Addendum No. 02

Subject: John F. Hartranft School

SDP Contract No. B-056, B-057C, B-058C of 18/19

UNI-VENT & TEMPERATURE CONTROL REPLACEMENT

E-600D

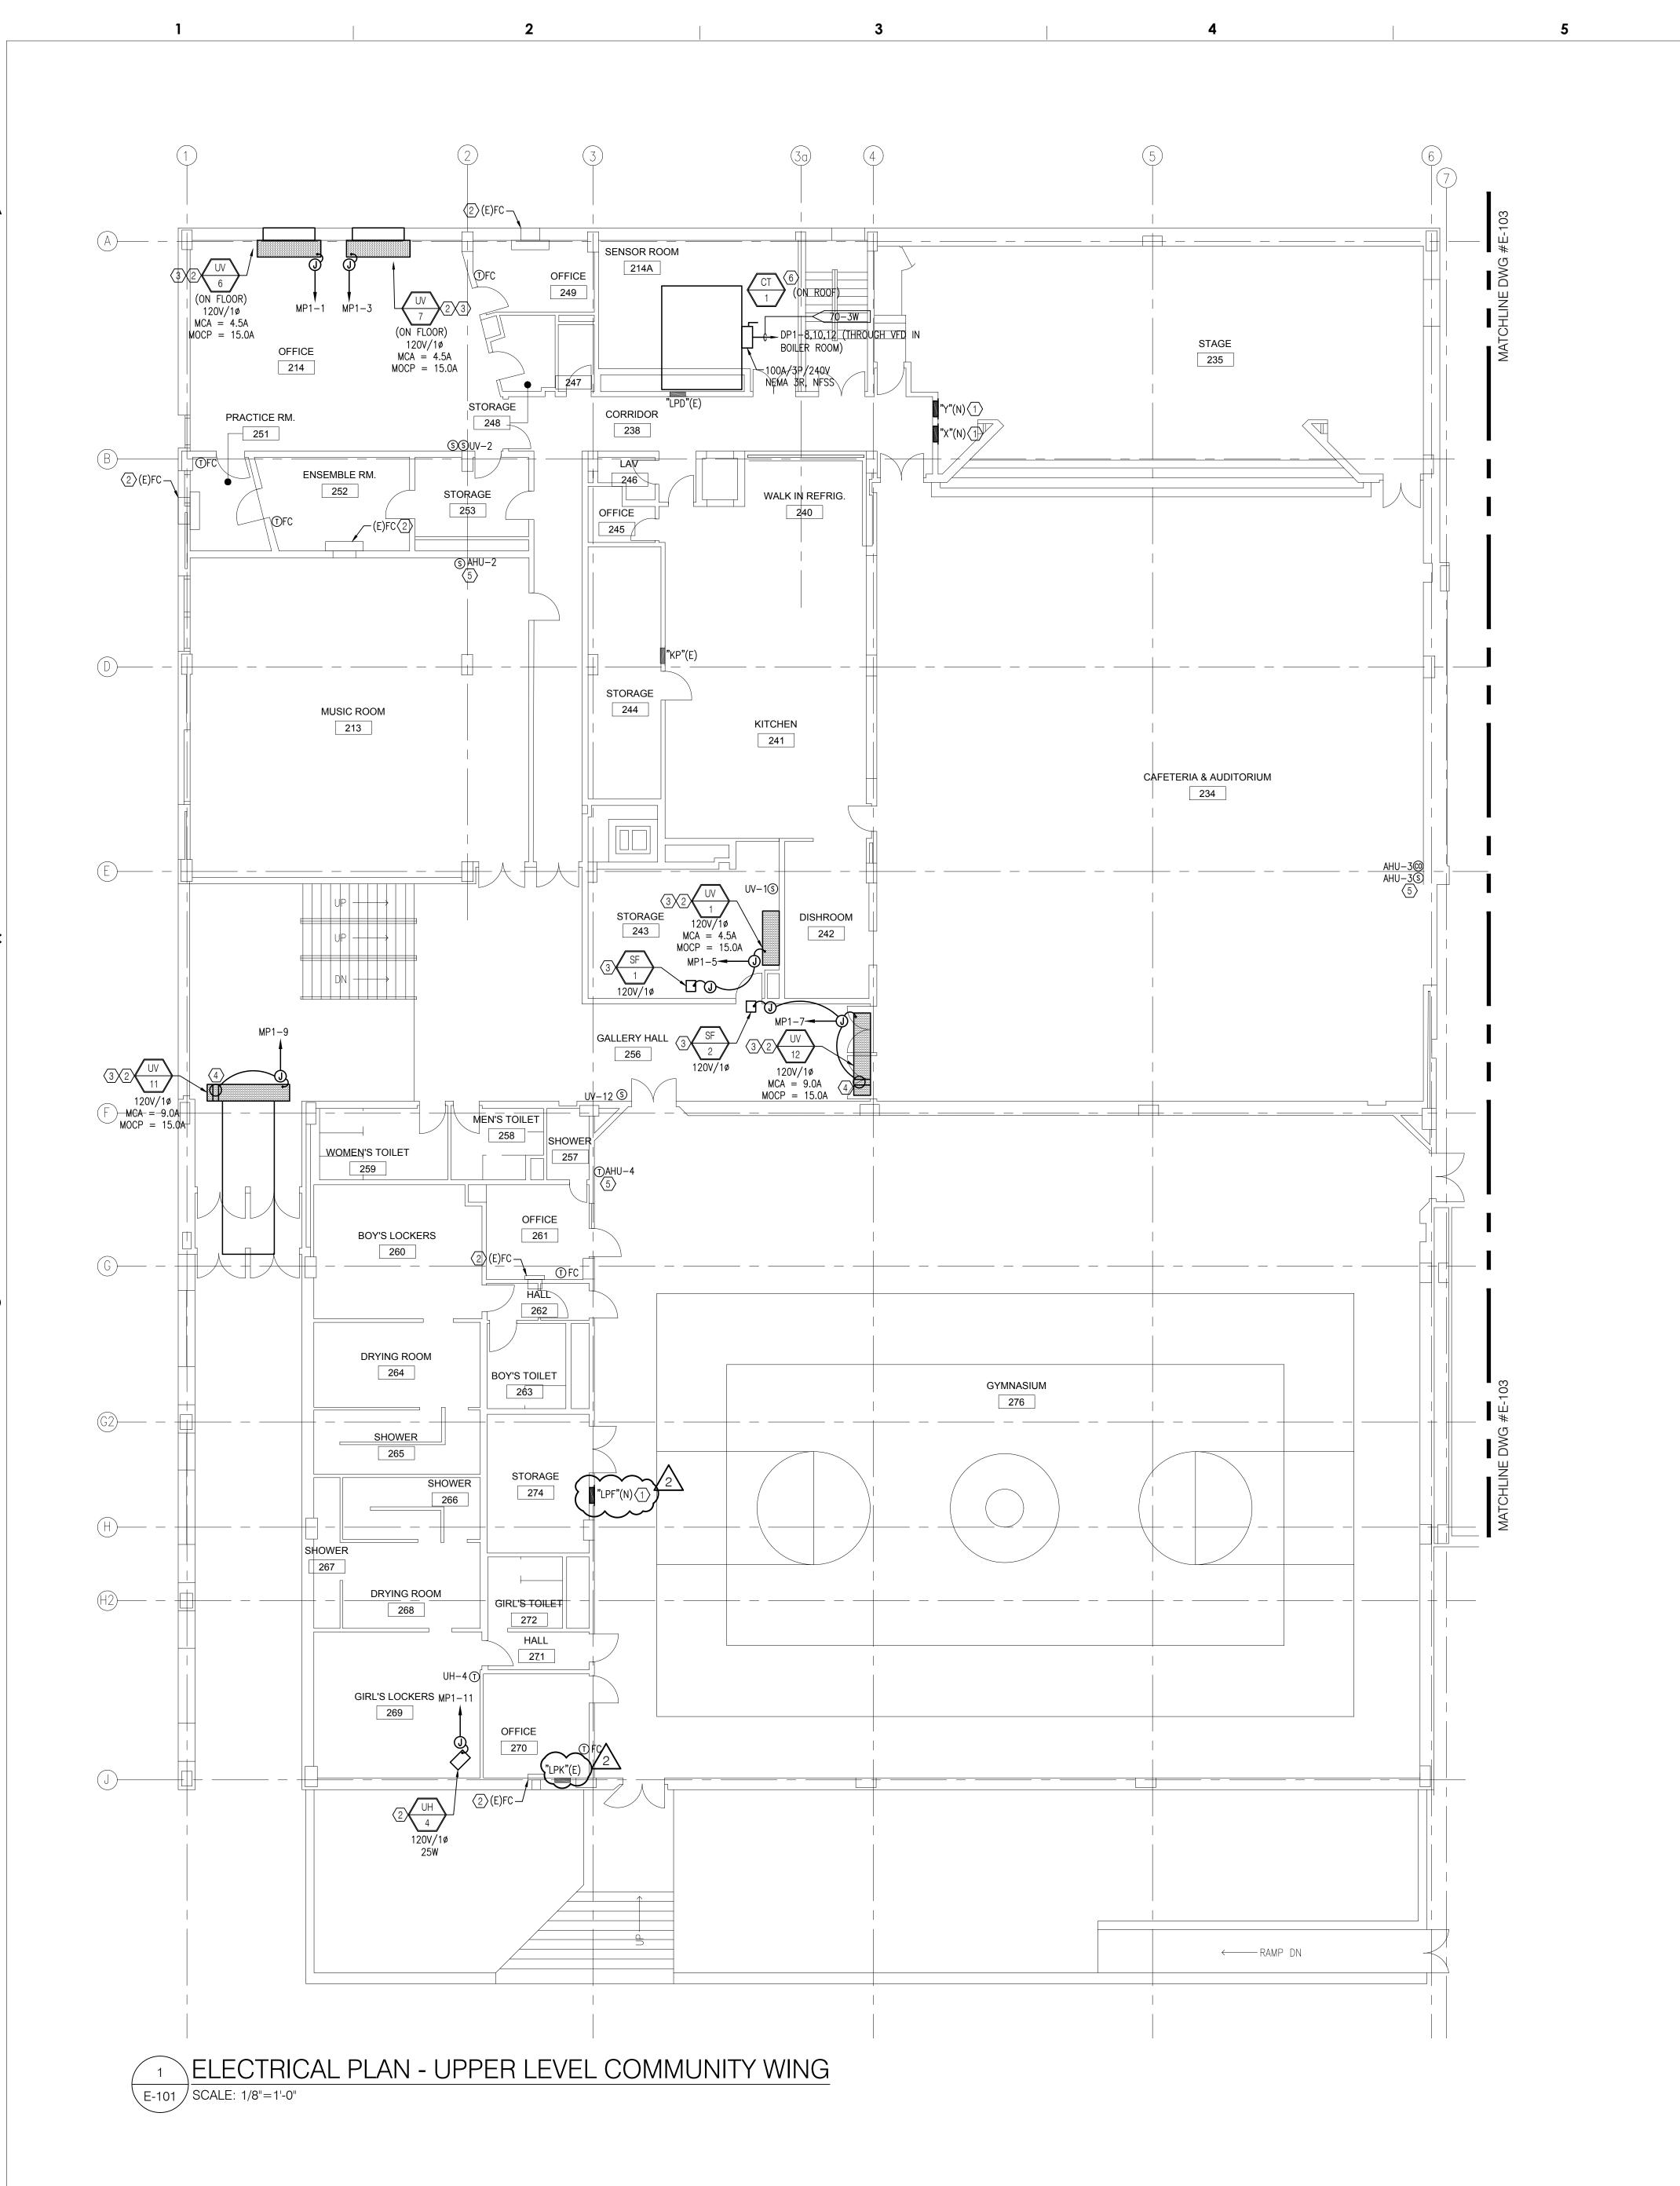
On E-101, there is a panel in the gym labeled "LPF" (N) with keynote 1. I believe this should be labeled as "LPE", because on E-101D the gym panel is labeled "LPE" (R) with keynote 1, and because another panel "LPF" is shown elsewhere. Panel LPE is not shown on the single line on E-600. Panel LPE is shown with keynote (1) on the demo single line on E-600D (the rectangle is labeled as "LPC" but the label underneath is shown as "LPE"). Please clarify if we are to replace panel "LPE" in kind. Please provide panel schedule. Please clarify where LPE is fed from and include the feeder size.

See Addendum #2 drawings, Sheets E-101D, E-600D, E-100, E-600, and E-601.

E-601

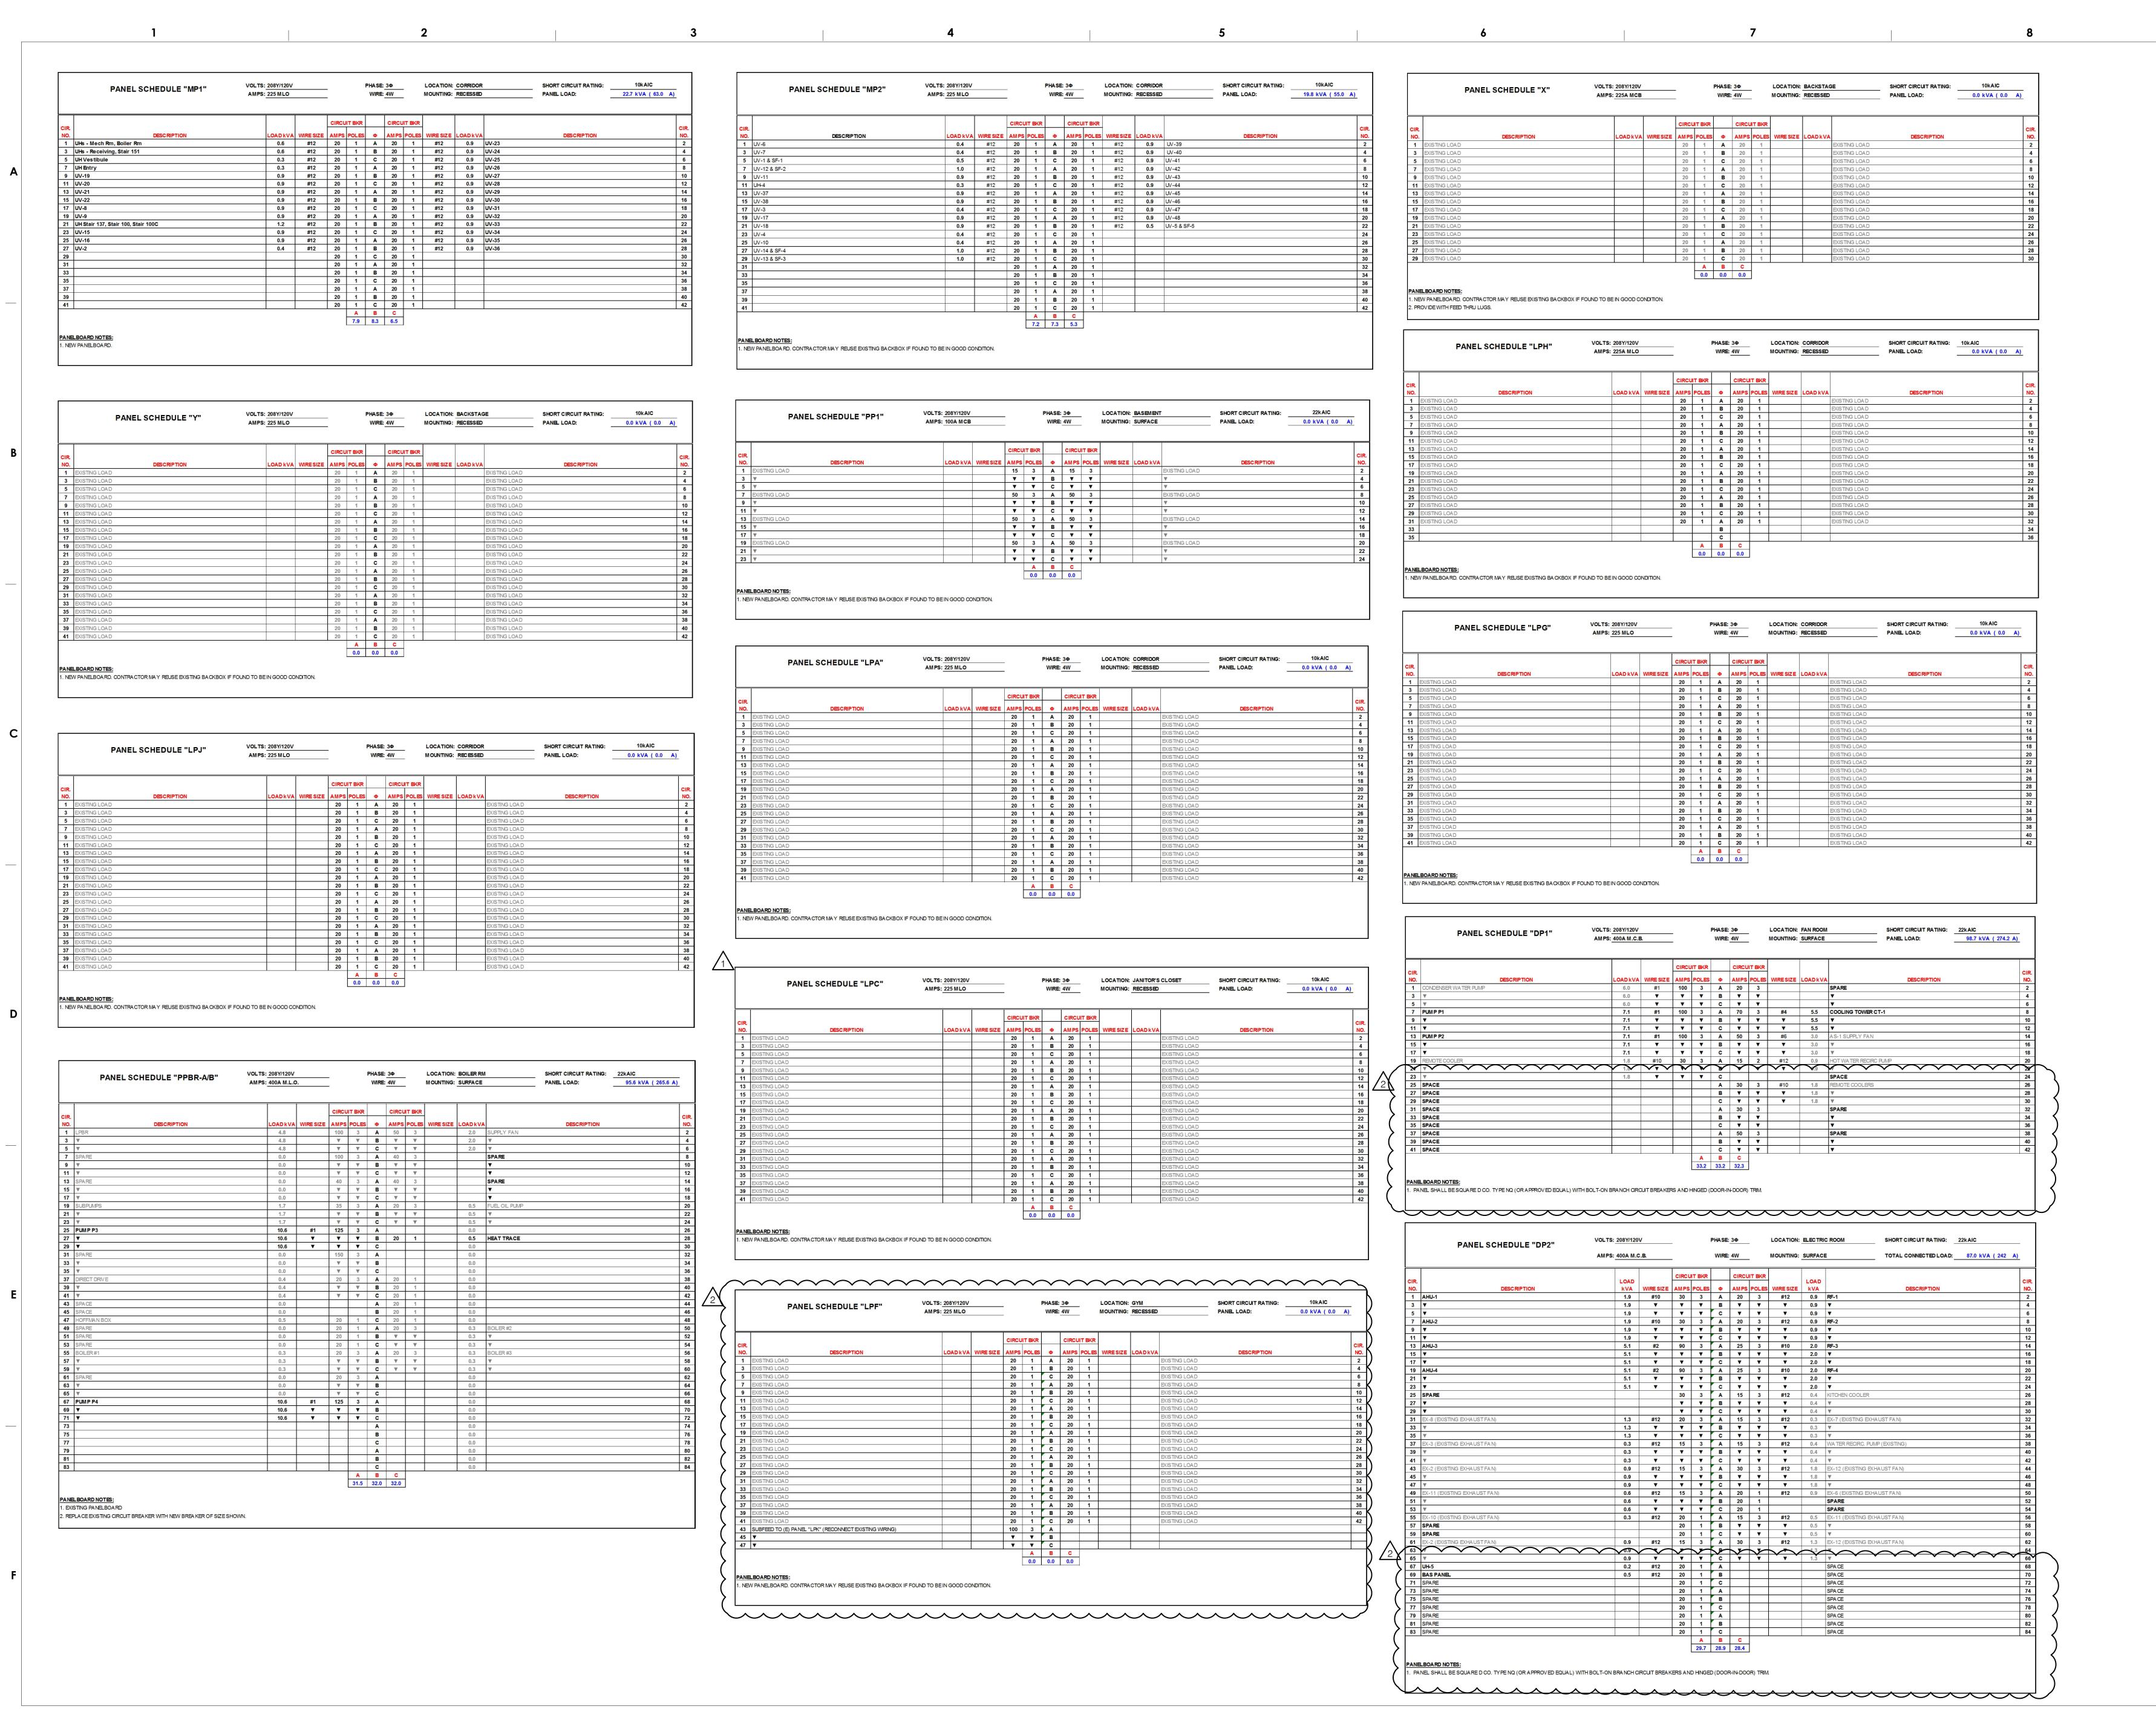
On E-401, the unit heaters, motor operated dampers, and BMS panel are each shown with a homerun labeled "DP2". These circuits are not shown in the single line on E-600, nor are they shown in the panel schedule on E-601. Please clarify circuitry, as this affects the number of breakers required in distribution panel DP2.

See Addendum #2 drawings, Sheet E-601 for panel schedule revision.
